OLIVE PARK RETAIL CENTER SR-20-2015

Administrative Site Review

Case File / Name: SR-20-15 / Olive Park Retail Center

SR-20-15 Preliminary Site Plan

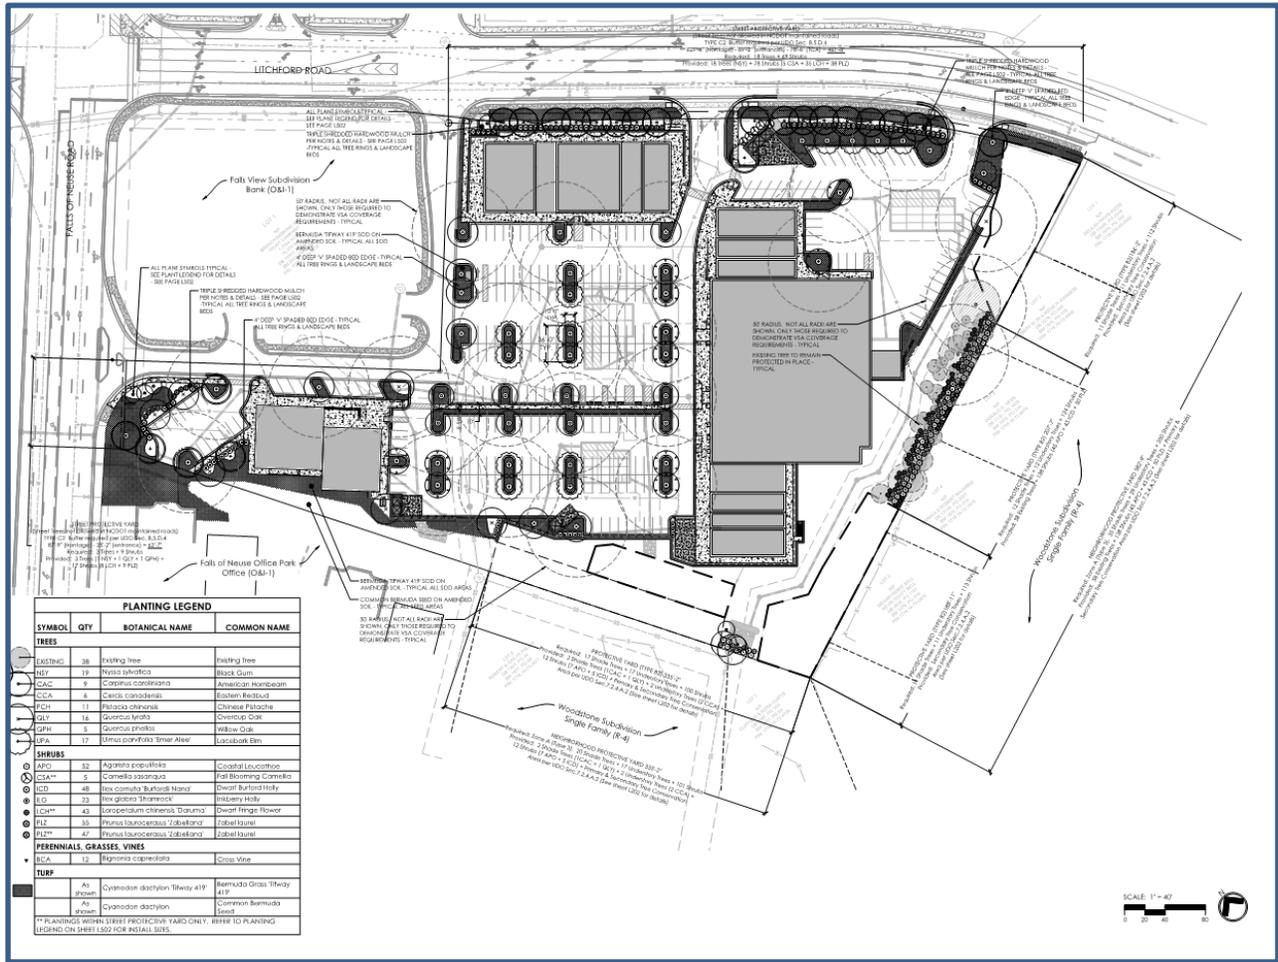
Administrative Alternate Findings:

The Planning and Development Officer may in accordance with Sec. 10.2.17. reduce the build-to requirement, subject to all of the following findings:

1. The approved alternate meets the intent of the build-to regulations;

2. The approved alternate conforms with the Comprehensive Plan and adopted City plans;

3. The approved alternate does not substantially negatively alter the character defining street wall or establish a build-to pattern that is not harmonious with the existing built context;

4. The change in percentage of building that occupies the build-to area or increased setback does not negatively impact pedestrian access, comfort or safety; and

5. Site area that would have otherwise been occupied by buildings is converted to an outdoor amenity area under Sec. 1.5.3.B.

Staff response: The project contains a building located within a range of building placement that supplements the existing street edge along Falls of Neuse Road. The alternate provides flexibility for the building to be moved further back from the street to help indicate a major ingress/egress that serves multiple parcels and buildings.

Staff response: The project conforms to several Comprehensive Plan policies, including policies of the I-540/Falls of Neuse Area Plan. The scale and design of the proposed building is similar to and reinforces the pattern of surrounding development along Falls of Neuse Road.

Staff response: The project proposes a building located behind two bays of on-site parking with cross access to adjoining parcels, which is consistent with neighboring parcels along Falls of Neuse Road.

Staff response: Pedestrian access is still maintained from Falls of Neuse Road to the proposed building with a pedestrian walkway along the access driveway.

Staff response: In addition to two bays of on-site parking with a single drive aisle permitted by the Parking Limited frontage, the applicant is providing two amenity areas within the area between the building and the street right-of-way.

The Planning and Development Director finds that the requested alternate generally meets the findings enumerated in the Unified Development Ordinance.
